Subject: Minutes for 63rd Protection Sub-Committee Meeting-reg

Minutes of
63rd Meeting of Protection Sub-Committee (PSC) of
Northern Regional Power Committee

Date and time of meeting : 29.09.2025 10.30 Hrs.

DR of 220kV Abdullapur(end)-Tepla Line-I

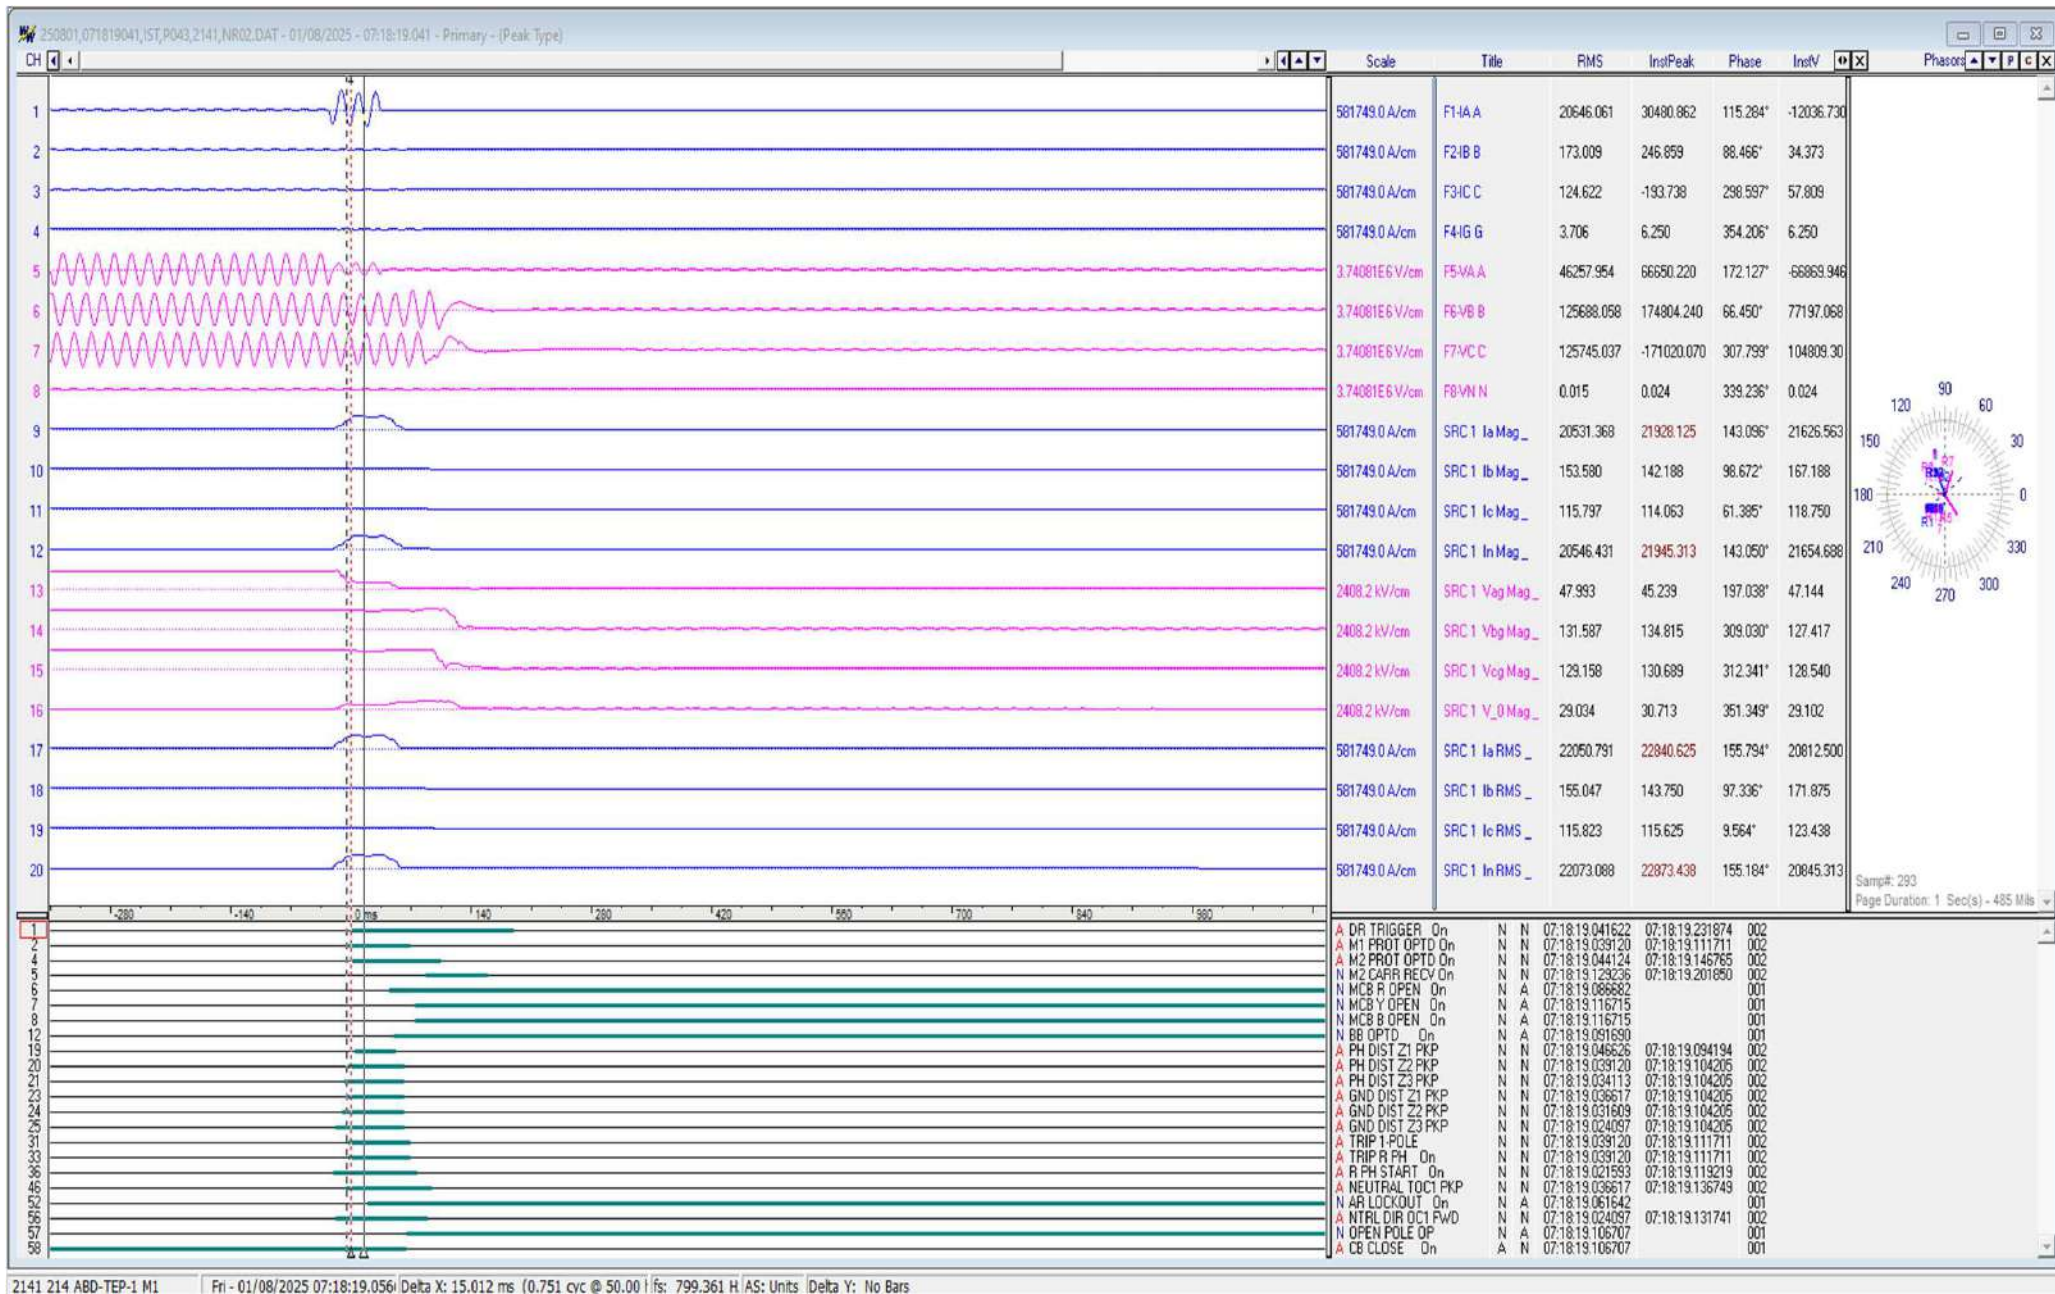
R-N fault, Z-1, ~20kA. A/R started but line tripped after ~60 msec due to Bus bar protection operation

DR of 765 KV Bara-Mainpuri (end) (UP) Ckt-2

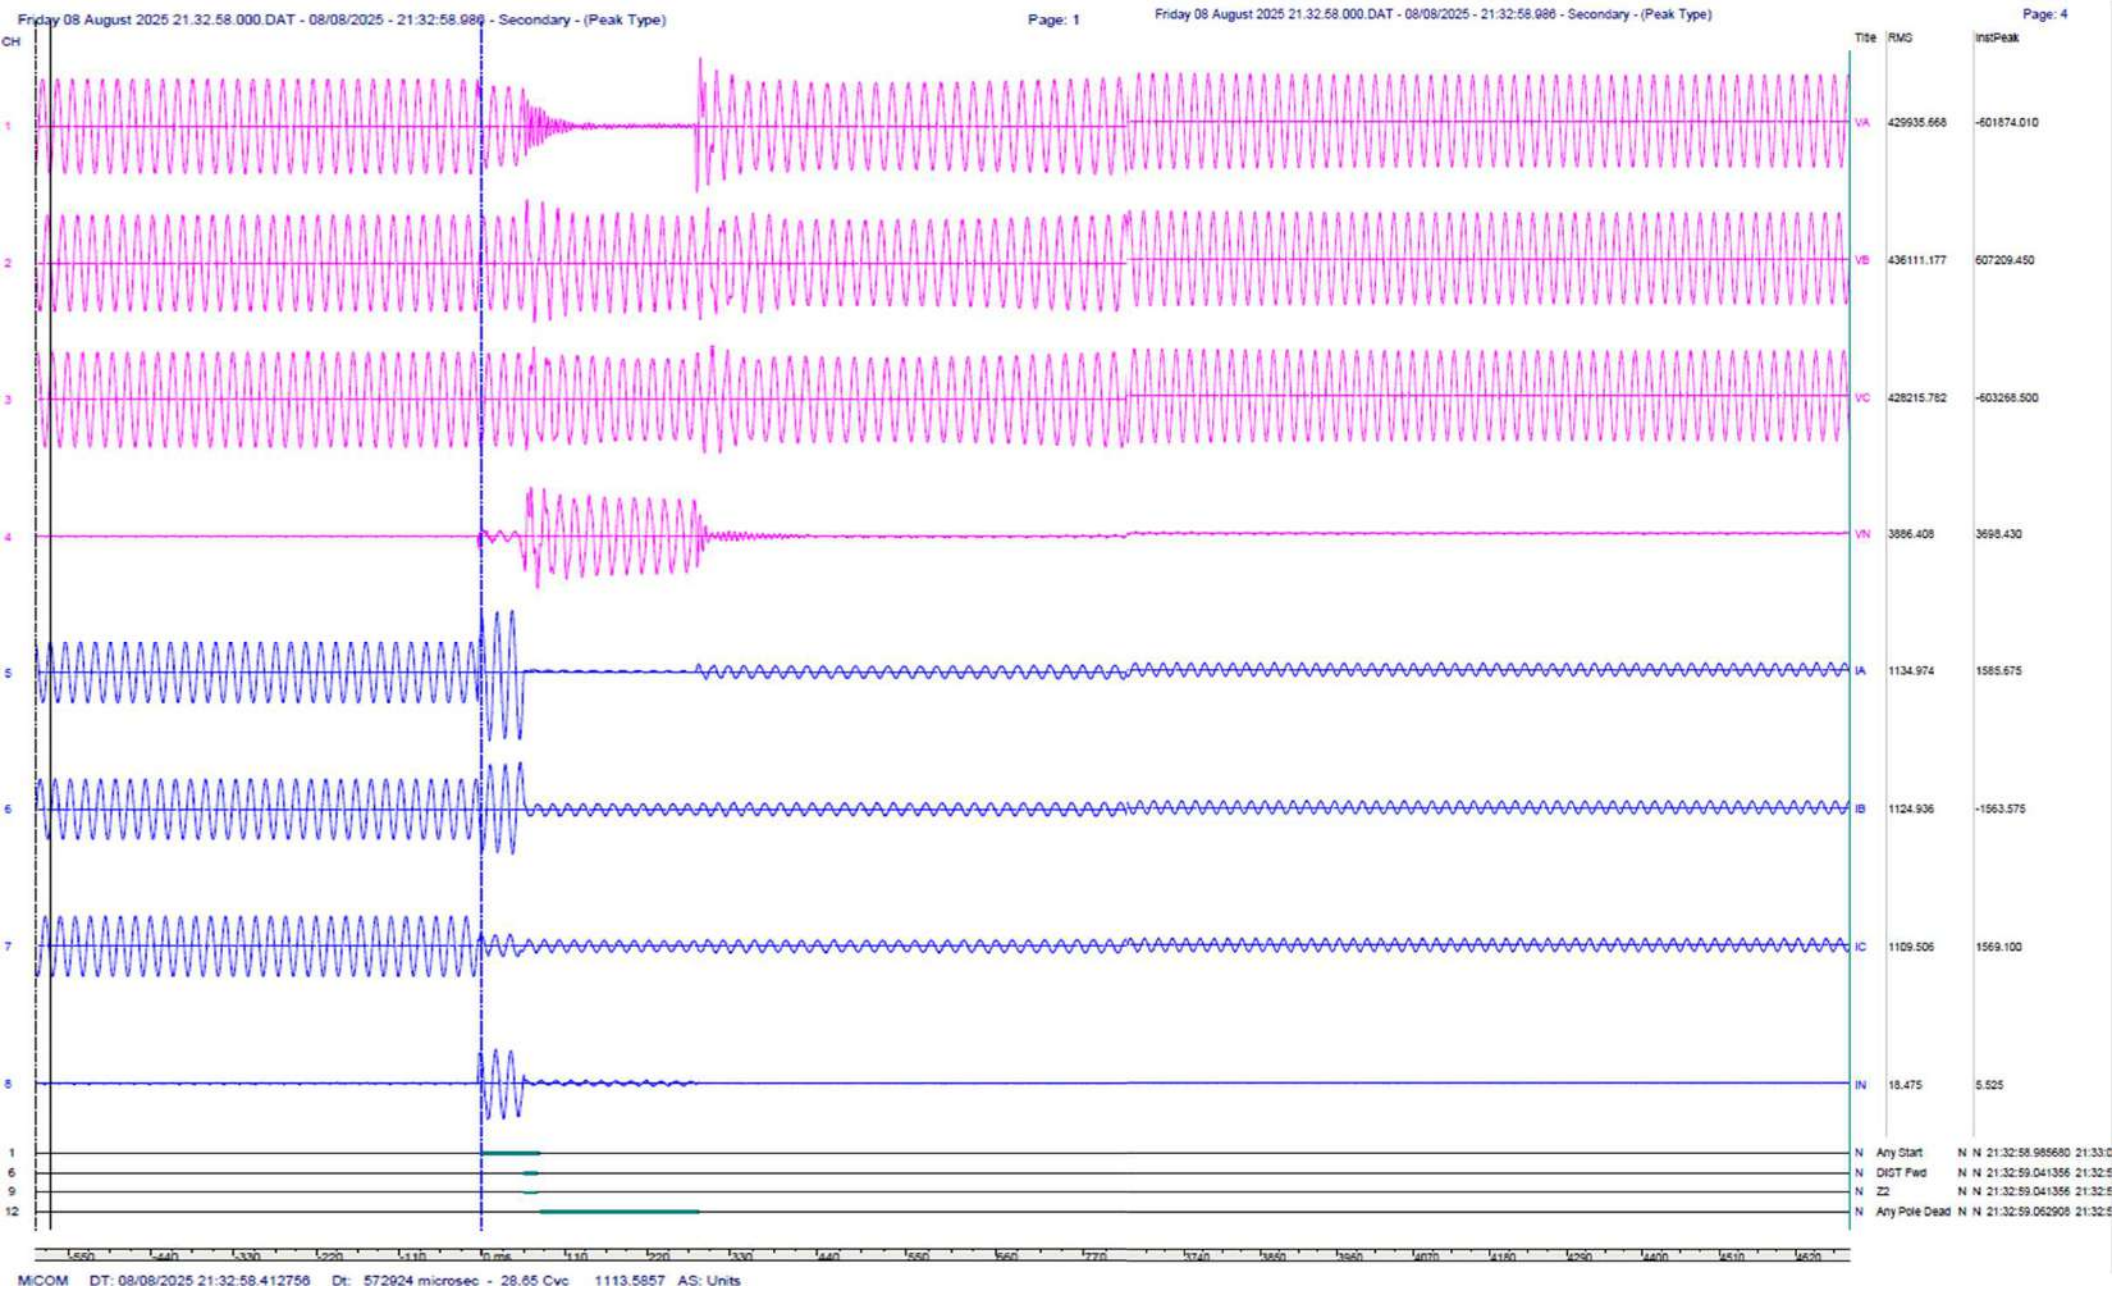
- ✓ R-N fault; fault current= $\sim 2.411\text{kA}$
- ✓ Fault sensed in zone-2, line tripped from Mainpuri end only

DR of 765 KV Bara (end)-Mainpuri (UP) Ckt-2

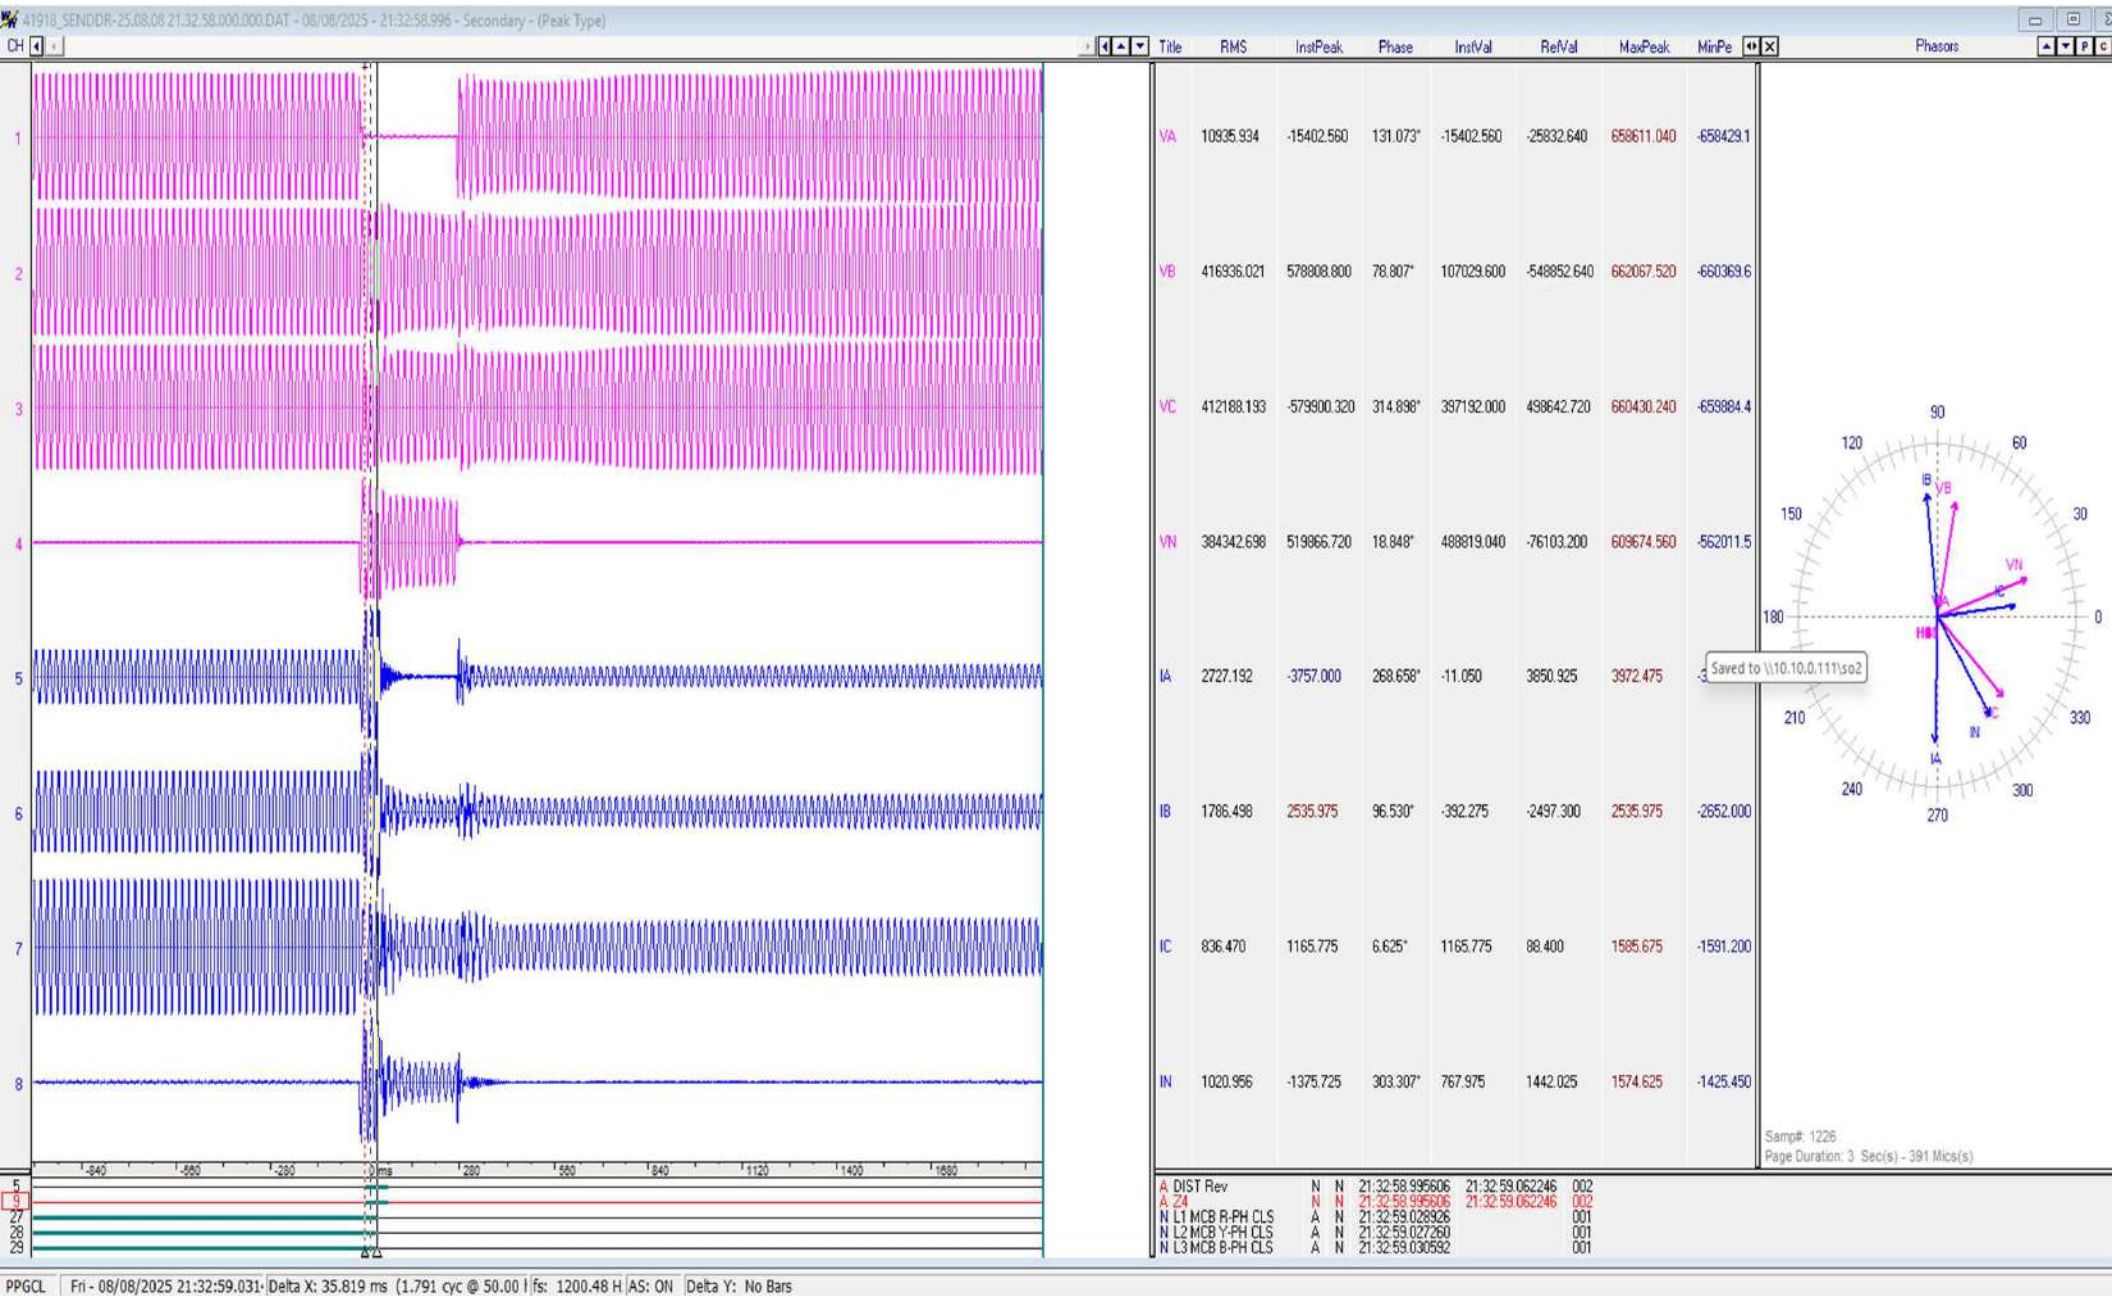
- ✓ R-N fault; fault current= ~ 2.727 kA
- ✓ Fault sensed in zone-4; line remained charged from Bara end

DR of 220 KV Khodri(UK) (end)-Majri(HP) (UK) Ckt-2

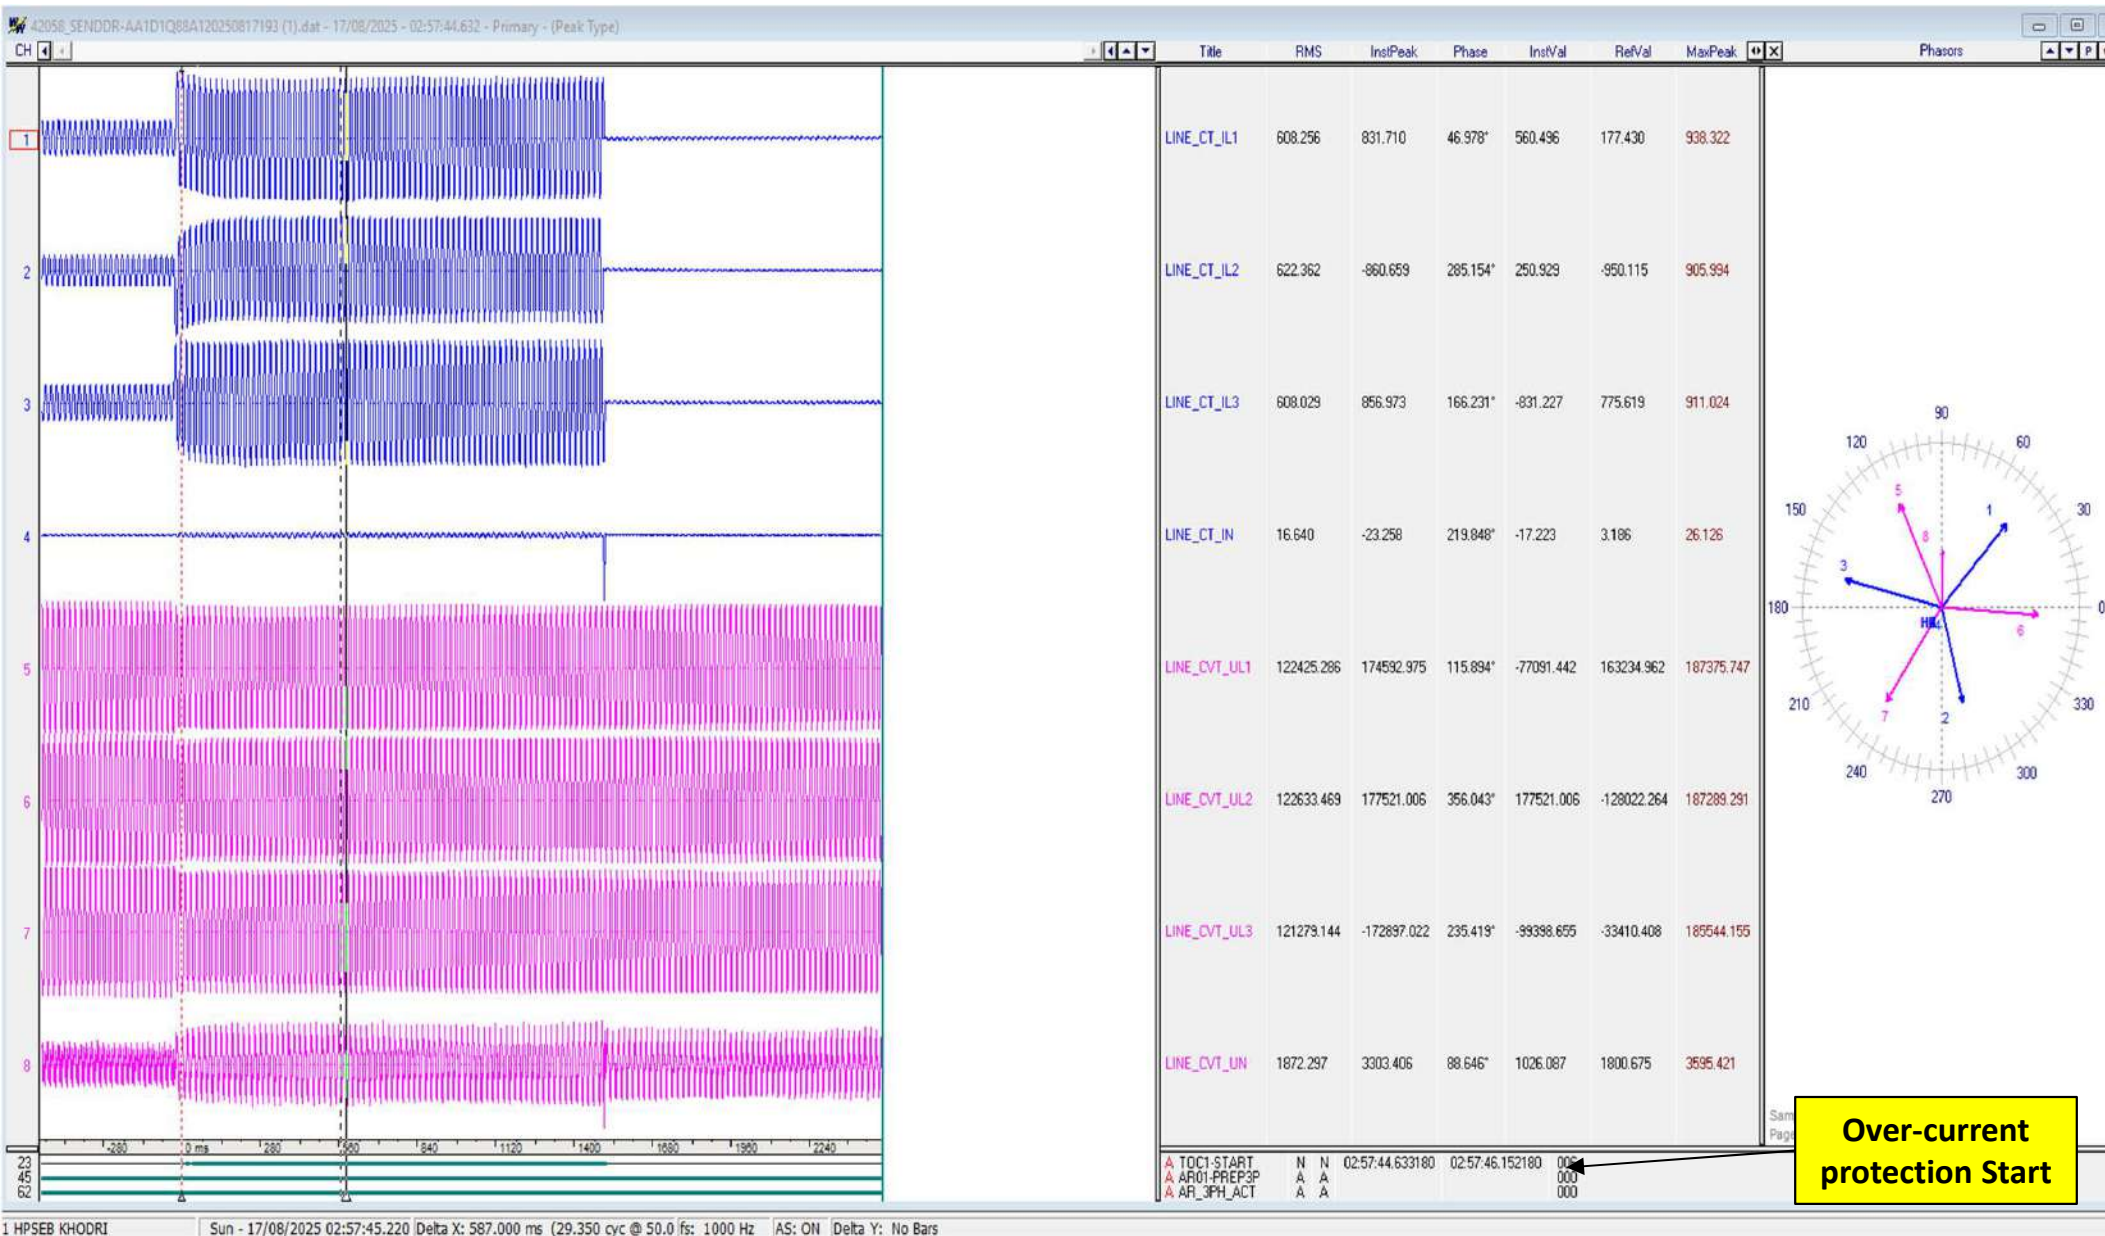
- ✓ $I_r \sim 608A$, $I_y \sim 622A$ and $I_b \sim 608A$
- ✓ Fault clearing time ~ 1.518 s
- ✓ Line tripped from Majri end only
